CENTRAL UTAH PROJECT

STREAM HABITAT STUDIES ON THE UINTA & ASHLEY NATIONAL FORESTS

March 30, 1972

We thank you for the opportunity to examine and respond to the Forest Service draft report on "Central Utah Project Stream Studies." Our staff fishery biologists have examined the report along with Jim Mullan of our Division of Fishery Services in Vernal. Mr. Mullan's comments represented very closely those generated by our staff people so we are forwarding a copy of his letter which will form our response to your letter of February 11, 1972.

Figure 1
 ROCK CREEK
 Station #1 - 150 feet below footbridge
 below Upper Stillwater Campground

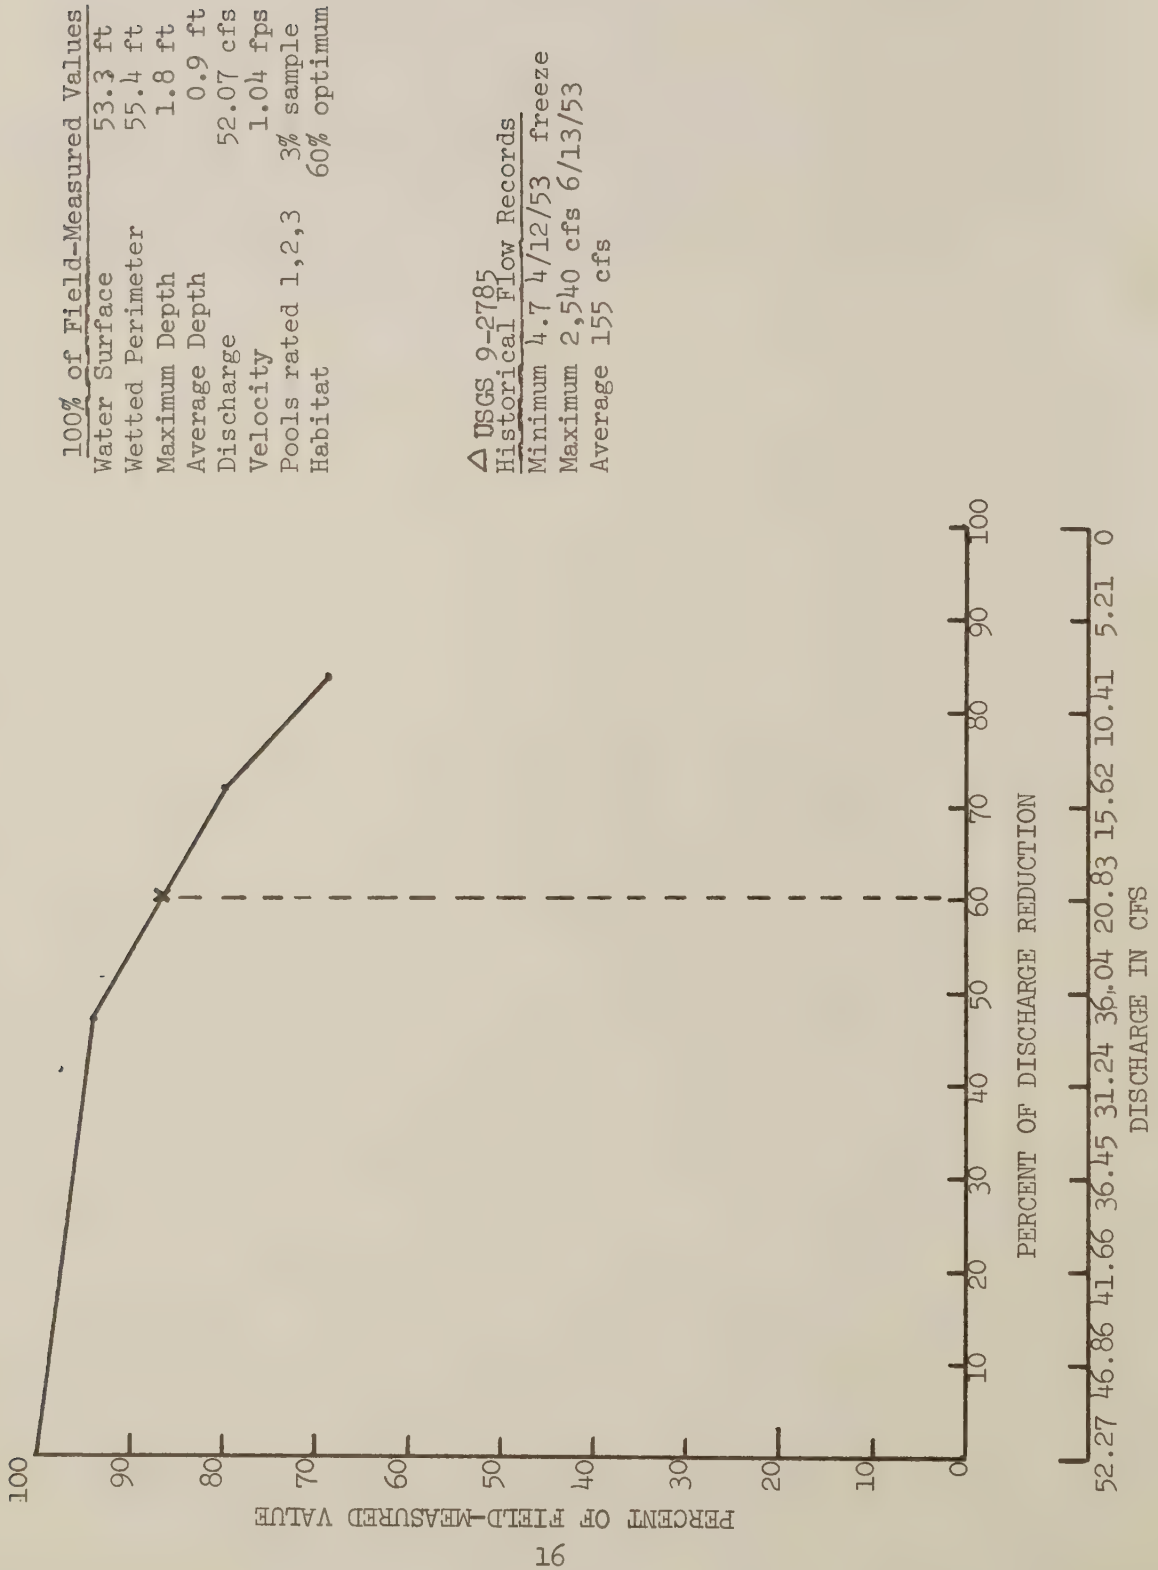
Page 16, Figure 1, under chart, DISCHARGE IN CFS, the figures "52.27" change to "52.07" and the figures "36.04" change to "26.04."
